**ARCHITECT'S ADDENDUM**

Addendum Number: 01

RE: Fort Zumwalt School District

Transportation Center

**FOUNDATION PLAN**  
1/8" = 1'-0"

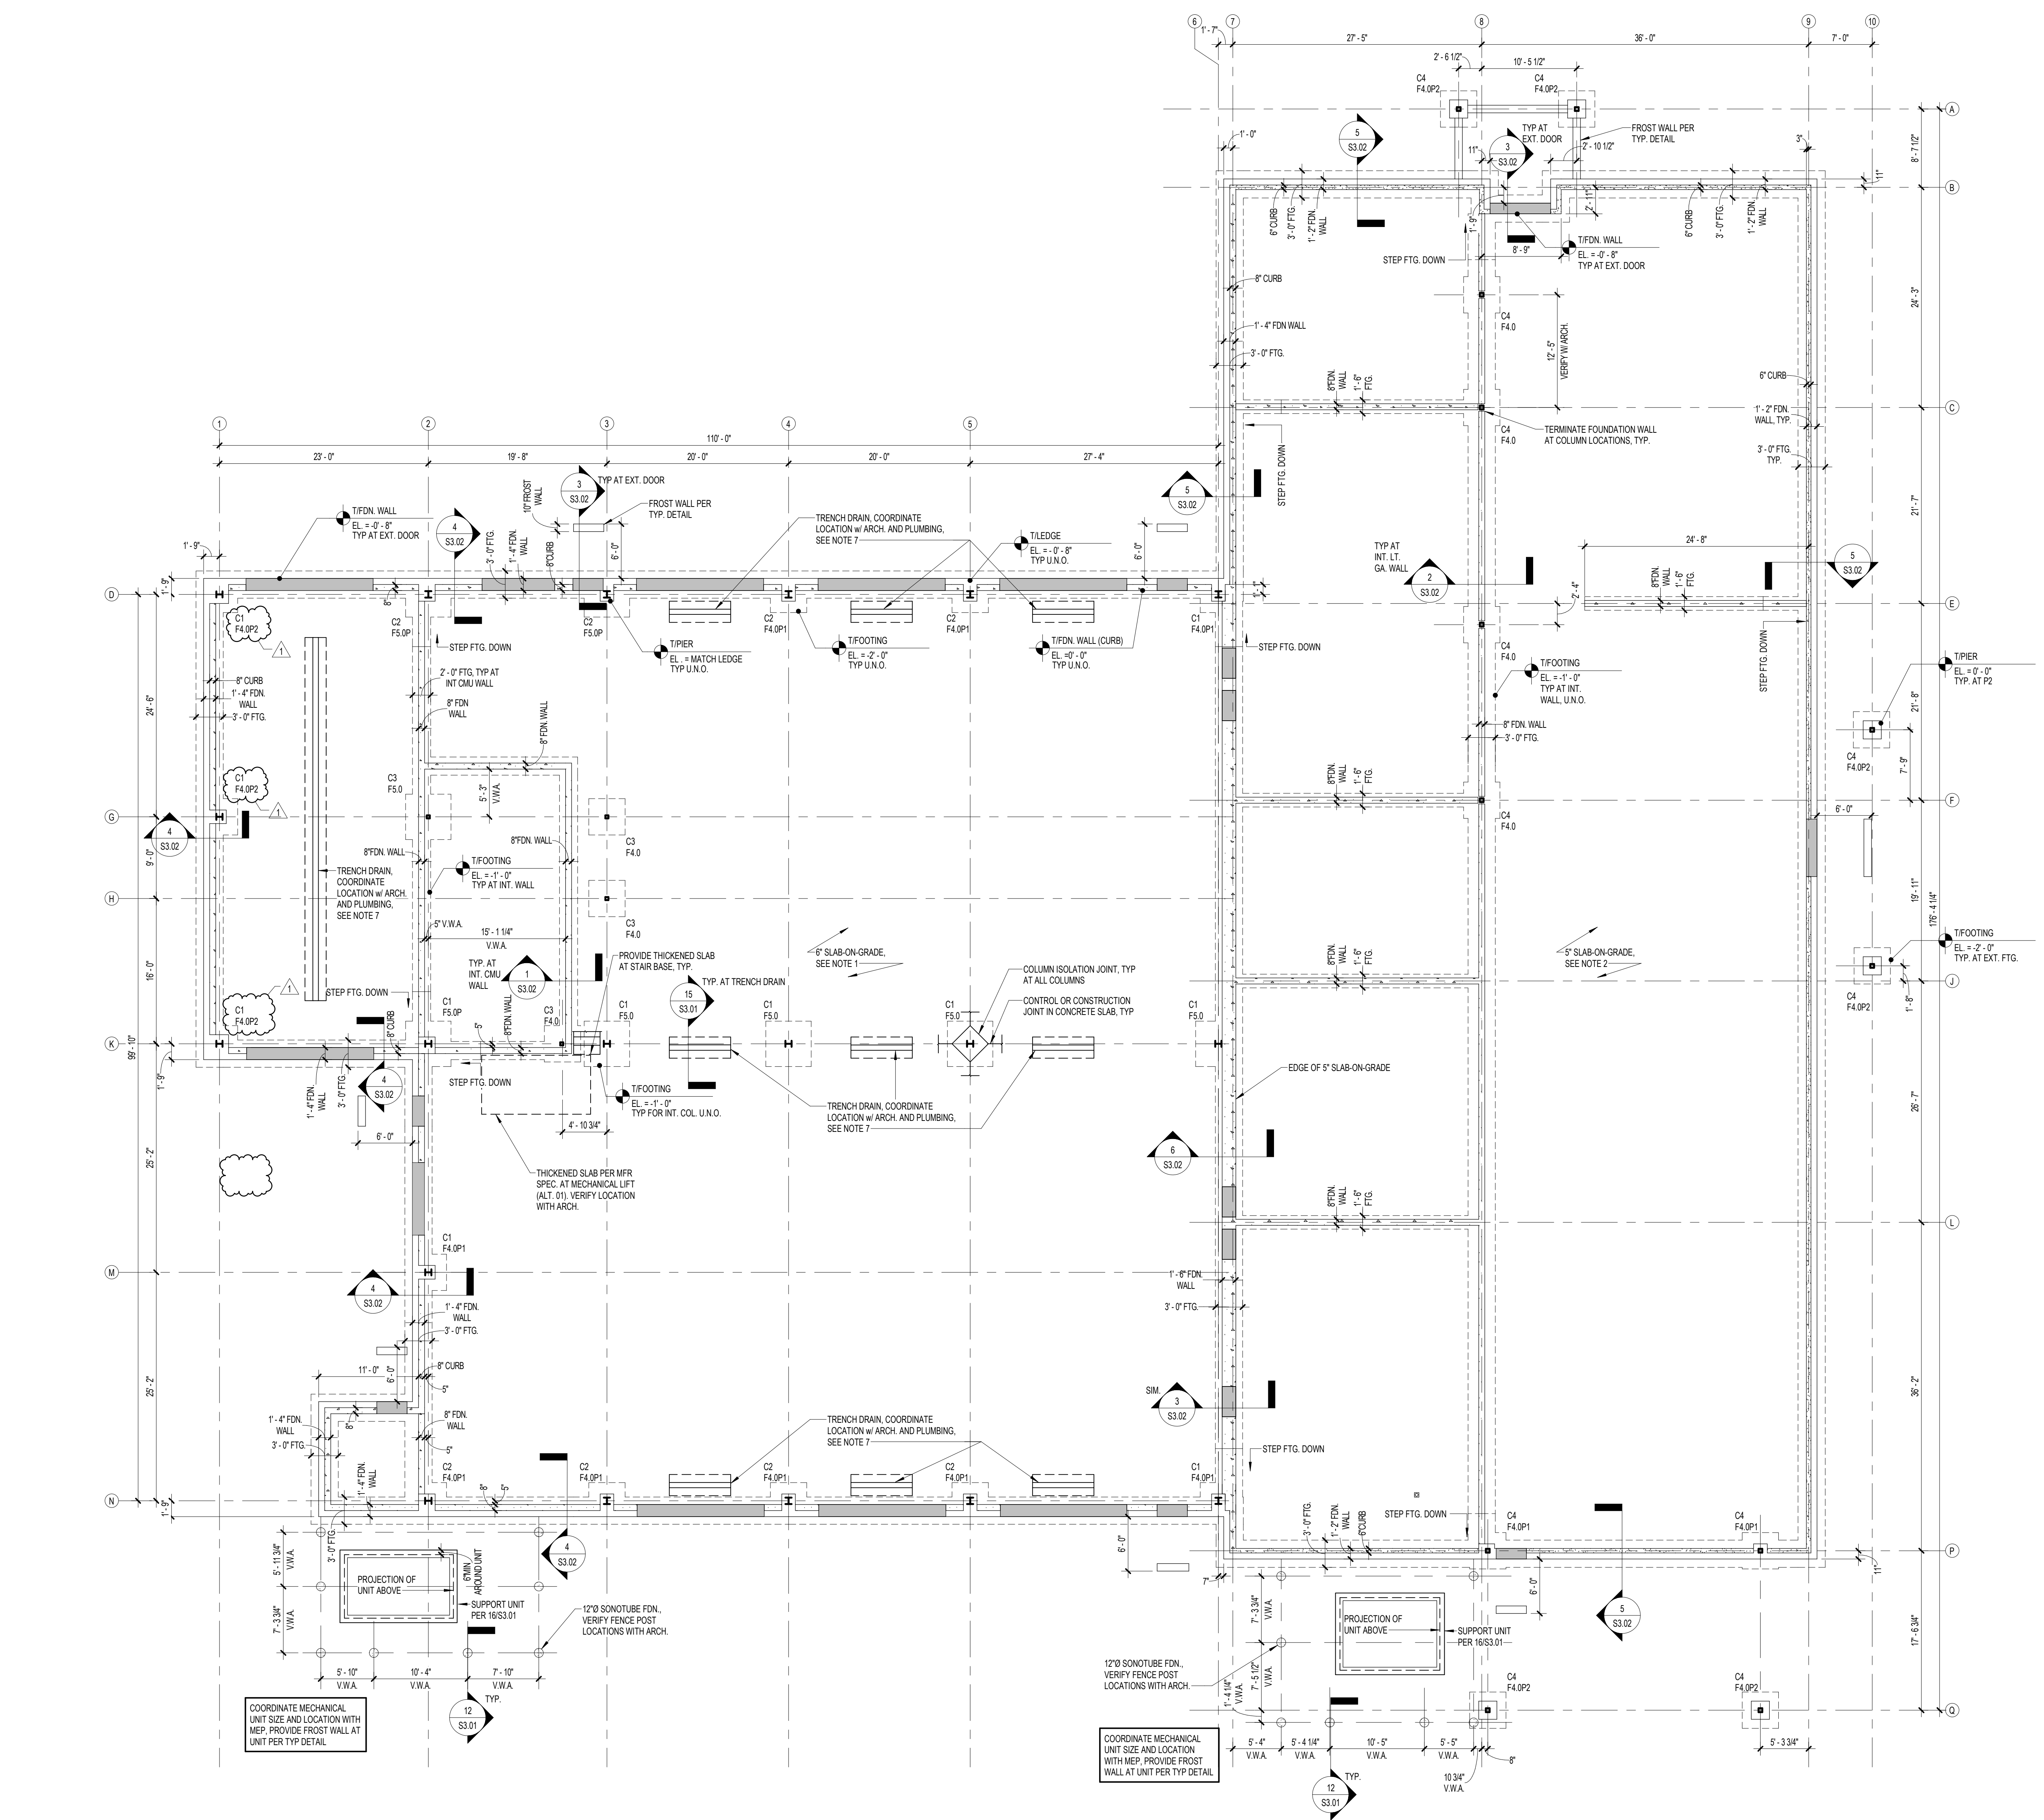
12. S2.01
  - a. Increased the pier size at the columns in Wash Bay 152 to accommodate the column enclosures.
13. S2.02
  - a. Added enclosures at the columns located in Wash Bay 152.

**1** FLOOR PLAN - LEVEL 01 - MECHANICAL HVAC  
M2.01 1/8" = 1'-0"

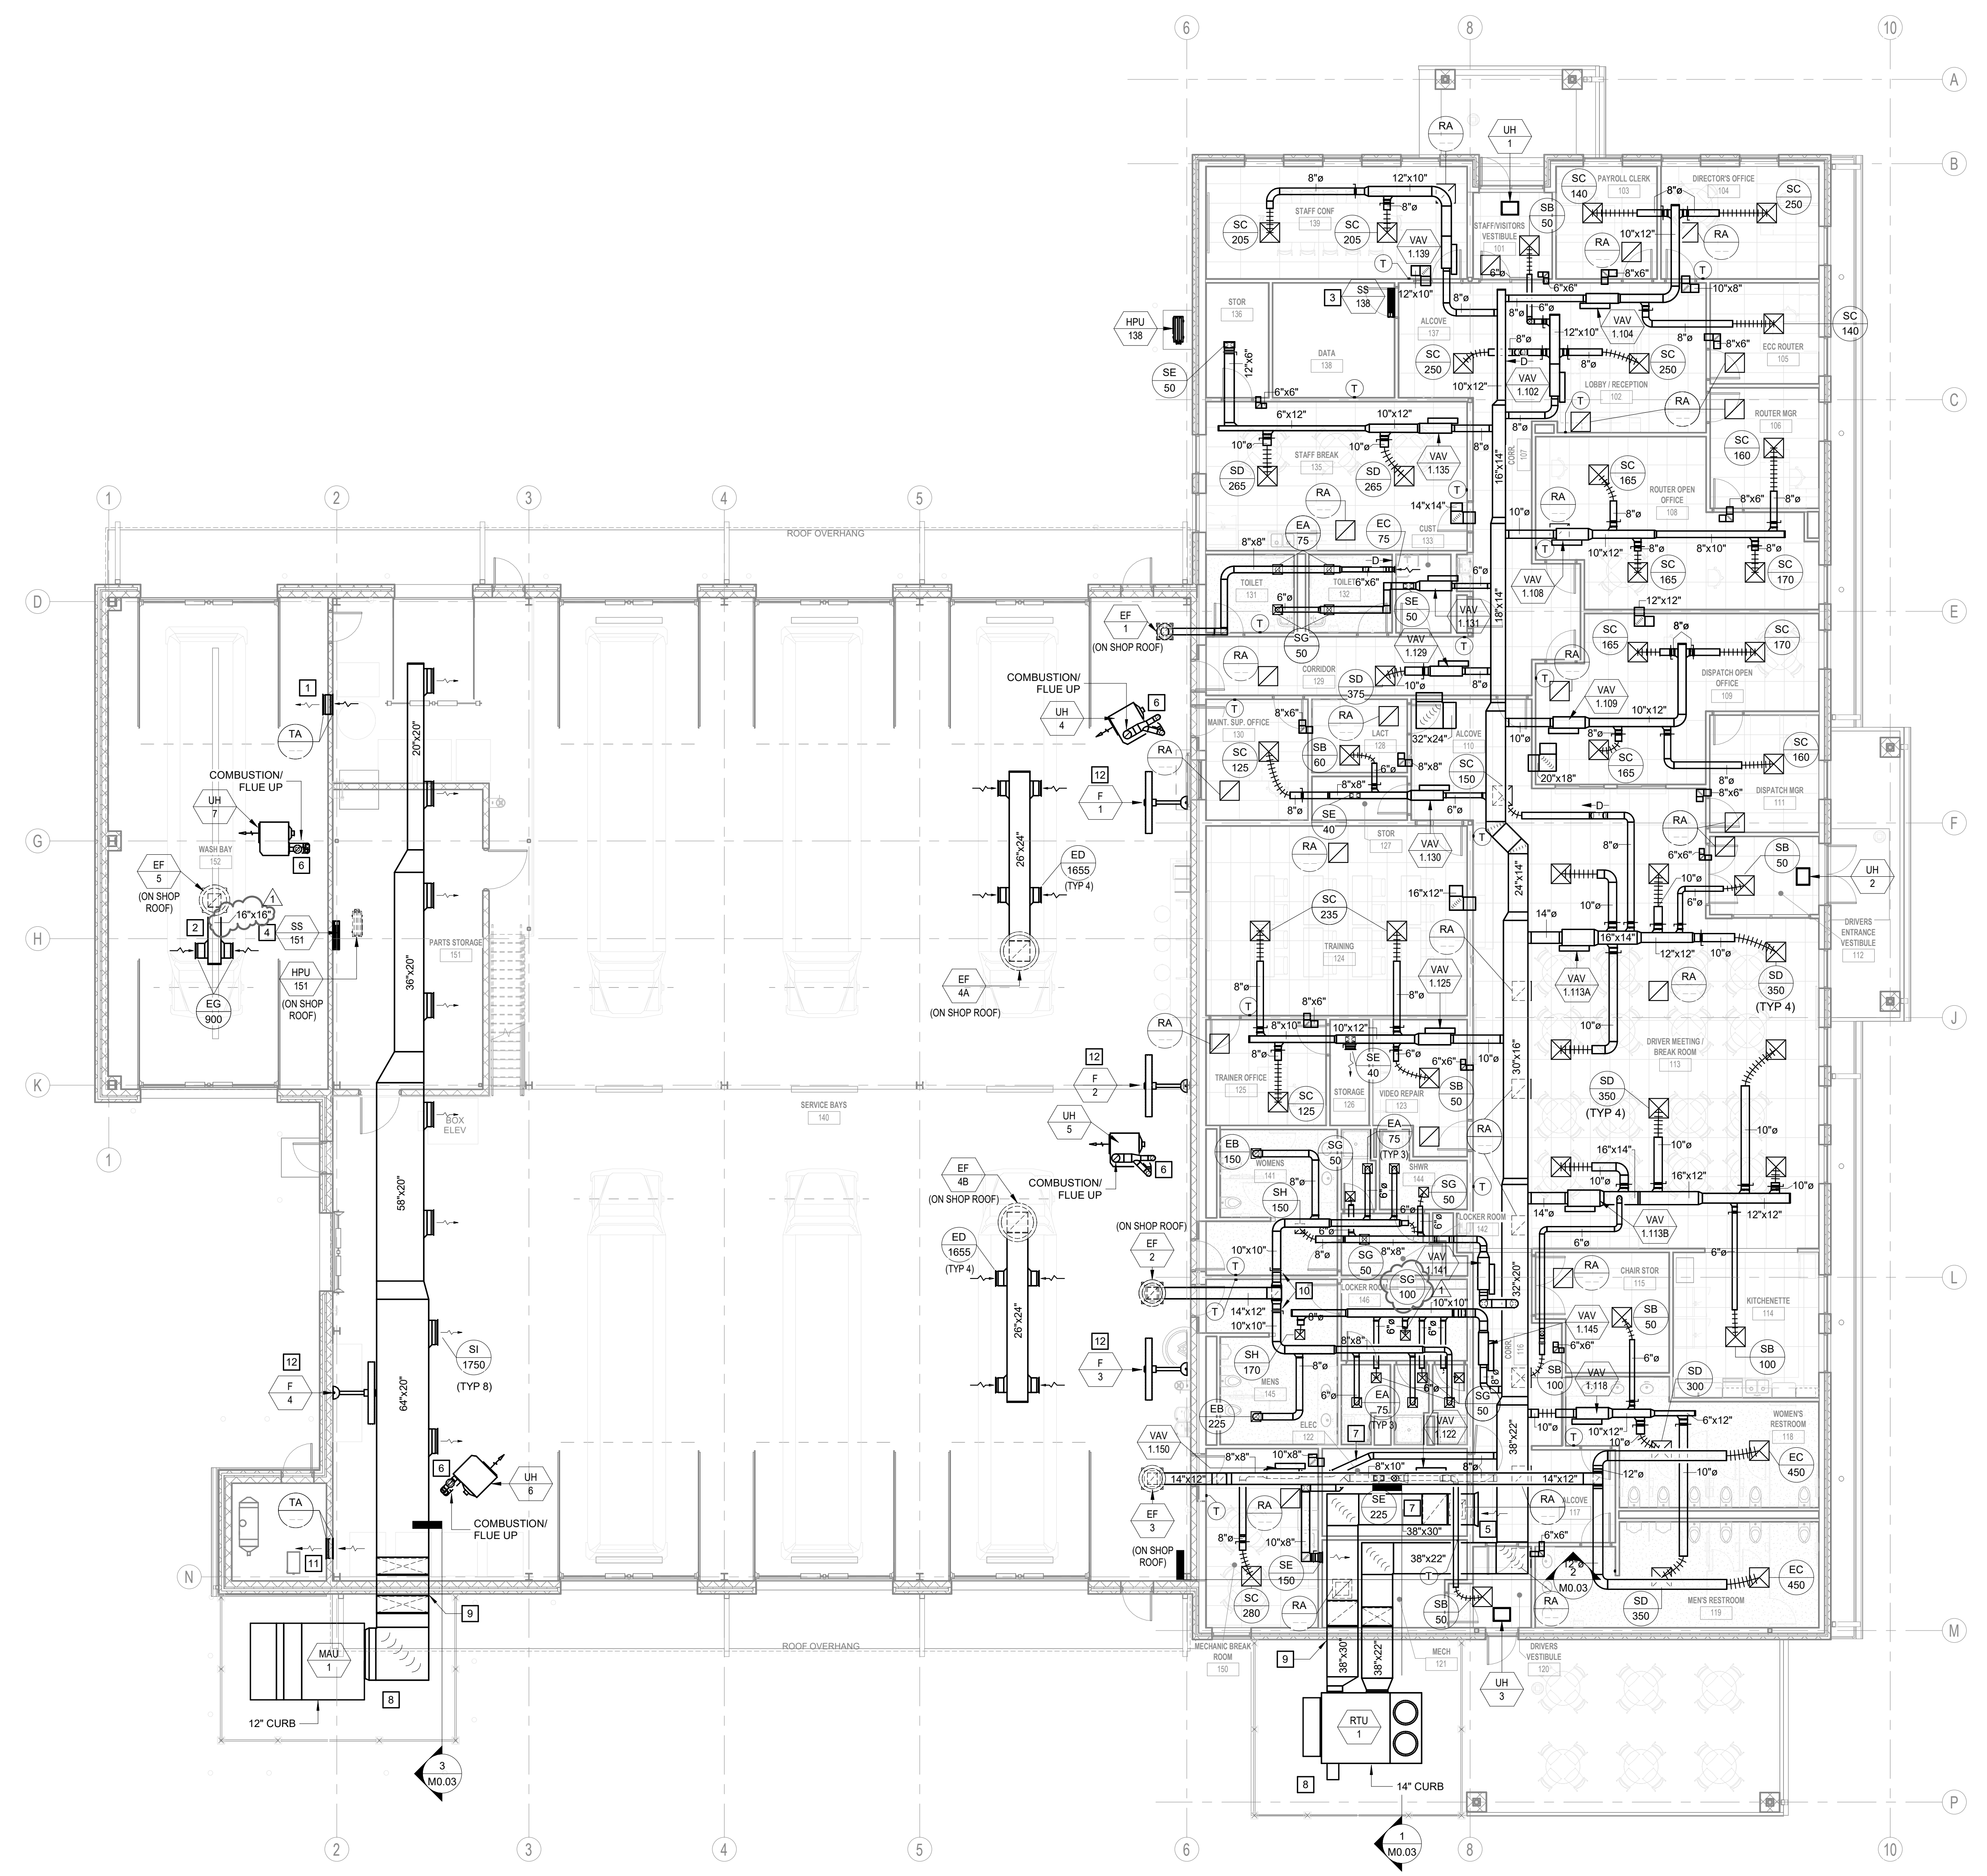
14. M0.01
  - a. Grille Schedule clarification – Grille schedule updated to show 'SH', 'SI', and 'EG'. Grille 'ED' size was revised.
15. M2.01
  - a. Grille revision – Grille in Locker Room 146 was changed from 'SH' to 'SG'.

- b. Exhaust clarification – duct size added to Wash Bay 152 exhaust duct (16"x16").
16. PF1.21
  - a. Added RPZ to keyed note 12 for automated washbay equipment feed water.
